Silicon Errata and Data Sheet Clarifications

The AT89C51IC2 devices you have received conform functionally to the current device data sheet (ww1.microchip.com/downloads/en/DeviceDoc/doc4301.pdf), except for the anomalies described in this document. The errata described in this document will likely be addressed in future revisions of the AT89C51IC2 devices.

44-Lead Plastic Thin Quad Flatpack (PT) - 10x10x1.0 mm Body [TQFP]

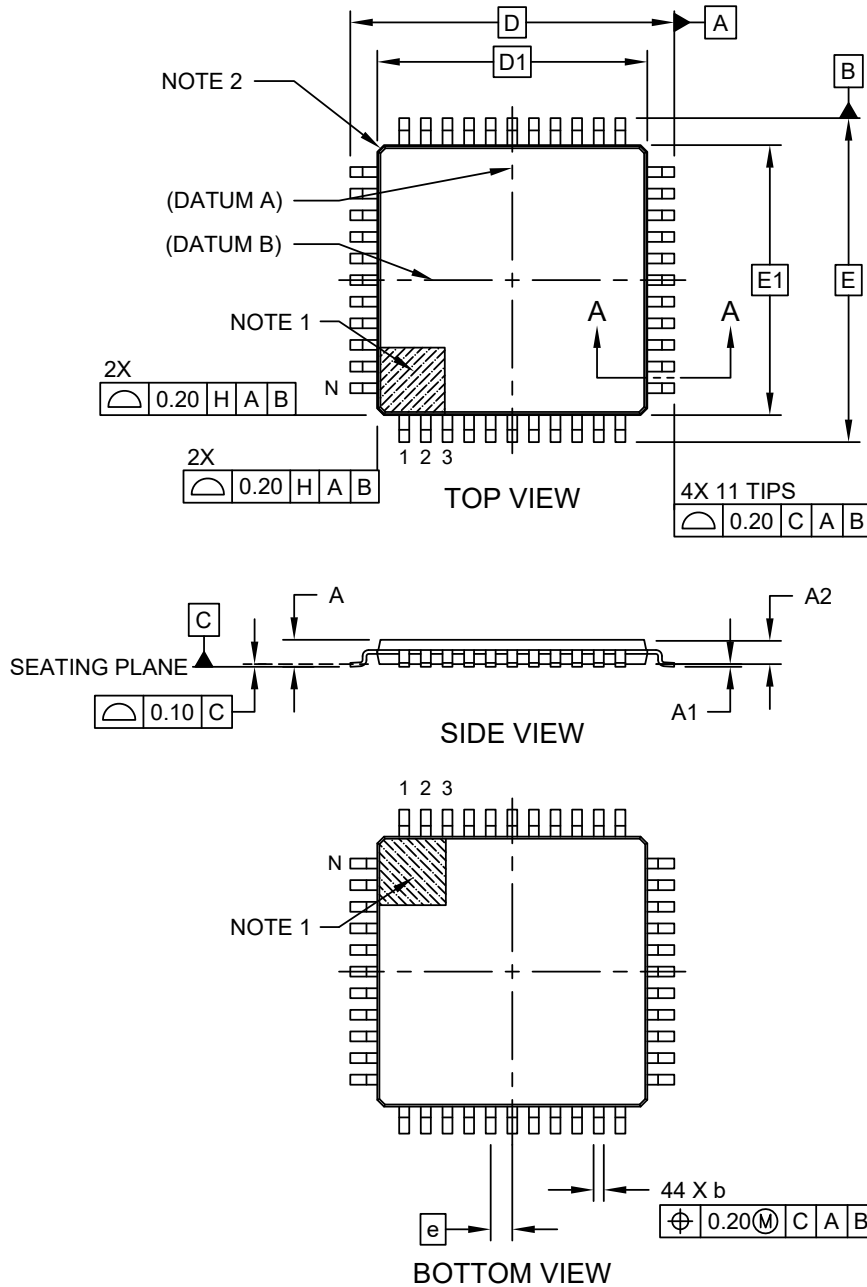
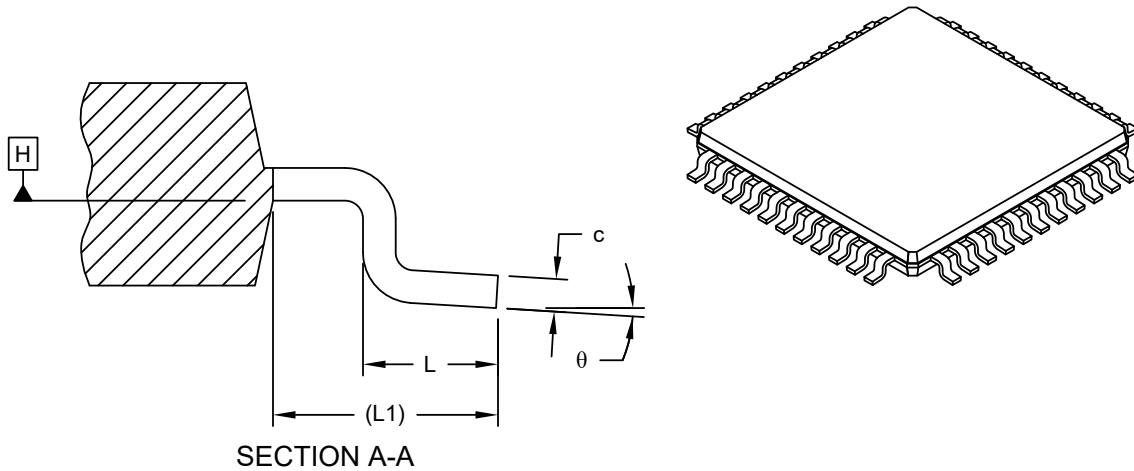
A clarification has been made to replace the VQFP package with a TQFP package.

A drop-in replaceable 44-lead TQFP with the same pinout, footprint, and based on the same die revision replaces the 44-lead VQFP package. There are no functional changes, hence all data sheet specifications are still valid for the replacement CPNs.

EOL	Replacement
Package type	44-lead VQFP (LQFP)	44-lead TQFP
Package style	2FB (Atmel GPC: AYP)	PT
Package Outline Drawing (POD) number	C04-21003	C04-0076

The TQFP package outline drawing is shown below.
